Re: Comments of Group Against Smog and Pollution; Buckeye Forest Council; and Center for Health, Environment, and Justice Regarding the Ohio EPA Air Program's Proposed Natural Gas Well Site General Permit

COMMENTS OF GROUP AGAINST SMOG AND POLLUTION; BUCKEYE FOREST COUNCIL; AND CENTER FOR HEALTH, ENVIRONMENT, AND JUSTICE REGARDING OHIO EPA'S PROPOSED NATURAL GAS WELL SITE GENERAL PERMIT

A production field tank battery made up of seven produced water tanks and seven condensate tanks. Tanks are ~400 bbl each.

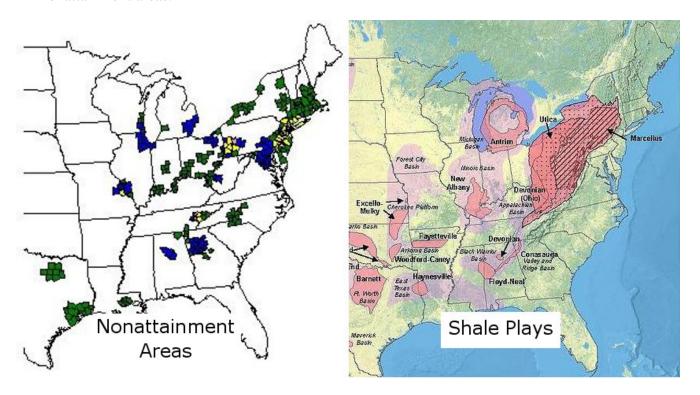
The capacity of typical produced water storage tanks range from 400-800 barrels (16,800 to 33,600 gallons), potentially exceeding both the OAC 3745-31-03(A)(1)(l)(iii) & (iv) capacity-based exemptions. Further, it is common industry practice to group multiple small condensate or produced water tanks together. Individually, these tanks are often small enough to meet capacity-based exemptions, but provide total storage capacity (and VOC emissions) equivalent to a large, non-exempt tank. Ohio EPA appears to be encouraging the use of multiple small exempt tanks by allowing a site to install up to 8 (or 10, according to the transmittal letter) tanks with a capacity no greater than 16,800 gallons each.

Colorado takes a sensible approach to regulating multiple-tank sites, its produced water tank general permit that applies to "produced water storage tank batteries comprised of a single storage tank or a group of storage tanks used for the storage of produced water,"²⁵ and focuses on cumulative emissions rather than emissions from individual tanks.²⁶ Like Colorado, Ohio EPA should look at cumulative characteristics when regulating multiple-tank projects. Cumulative storage capacity must be used to determine applicability of capacity-based exemptions; otherwise sources can circumvent permitting and pollution control requirements by simply using two small, permit exempt tanks in place of a larger tank that would be subject to regulation. Thus, the capacity-based exemption should not apply unless cumulative storage capacity remains under the exemption threshold.

Colorado has established a 95% VOC control requirement for produced water storage tanks; ²⁸ Wyoming requires 98% control. ²⁹ Ohio EPA should take a conservative approach and establish similar VOC control requirements for produced water storage tanks in the draft general permit. The well site owner or operator could avoid this control requirement by providing representative produced water composition data demonstrating that produced water vapor pressure is below a threshold vapor pressure (such as the 3.5 kilopascals exemption threshold in OAC 3745-31-03(A)(1)(l)(iv)). ³⁰ Colorado has developed county-specific produced water emission factors. ³¹ Ohio may be able to develop similar geographic emission factors for use in future produced water tank permitting decisions on the basis of these produced water composition data submissions, eliminating the need for site owners or operators to submit produced water composition data in the future.
